**PLANNING AND  
DEVELOPMENT DEPARTMENT**

**SR-2 – ADVISORY STAFF REPORT (05-08-2026)**

**ADDRESS:** 1000 ST. ANNE AND 2635 W LAFAYETTE

**APPLICATION NUMBER:** HDC2026-00195

Photos of three sacristy windows provided for replacement/replication. Provided by the applicant

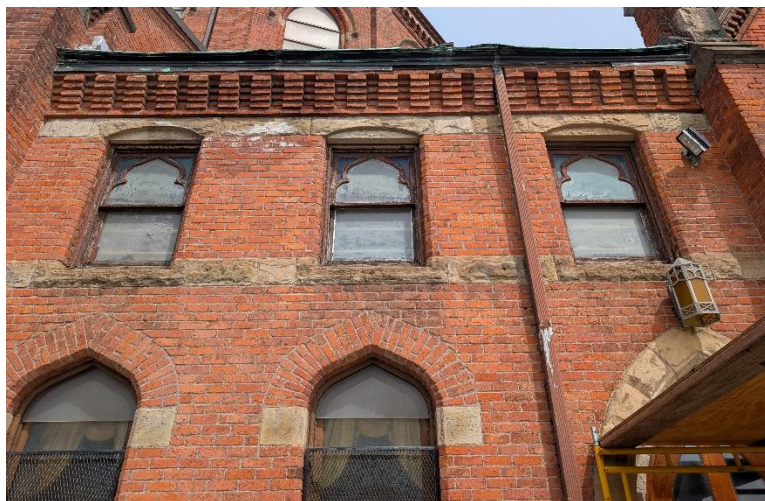
- The April 8, 2026 application (HDC#2026-00107) proposed to replace three wood windows at the building’s sacristy/west wall. The Commission denied the work item because the April 2026 submission did not include the level of documentation necessary to substantiate that the three distinctive, historic character-defining wood windows at the second floor, 2-story portion of basilica (sacristy) which were proposed for replacement were deteriorated beyond repair. Specifically, the application only provided three photos of the windows. Also, the application did not provide the level of documentation necessary to determine if the proposed replacement windows would adequately match the original/existing historic windows.

- With the current submission, the applicant has provided a number of photos to document the condition of the windows. Furthermore, HDC staff visited the site on April 27, 2026 and assessed the condition of the windows in situ. After a review of the submitted photos and the windows in situ, HDC staff determined that the windows were deteriorated beyond repair.

- The application proposes to custom make new wood windows which will replicate the existing. Specifically, per the current application “ ...the proposed custom replacement wood windows will match the historic wood windows in design (size, pane configuration, trim details, planar and reflective qualities), color, and materials. The dimensions of the custom replacement wood window components (the rails, stiles, and muntins) will match the dimensions of the original window components...Where sound/intact, existing historic glass panes will be retained and reused/reinstalled as part of the replacement window unit. Where sound/intact, existing historic brickmold will be retained and reused/reinstalled as part of the replacement window unit.”

- The applicant does not currently have specifications for the replacement windows because they will be ascertained upon the removal of the windows.
- Staff recommends approval of this work item on condition that staff be afforded the opportunity to review and approve the final specifications/shop drawings for the new windows prior to their installation to ensure that the units match the windows proposed for replacement.

- With respect to the three windows proposed for replacement at the basilica/church's sacristy area, staff be afforded the opportunity to review and approve the final specifications and shop drawings for the new windows prior to their installation
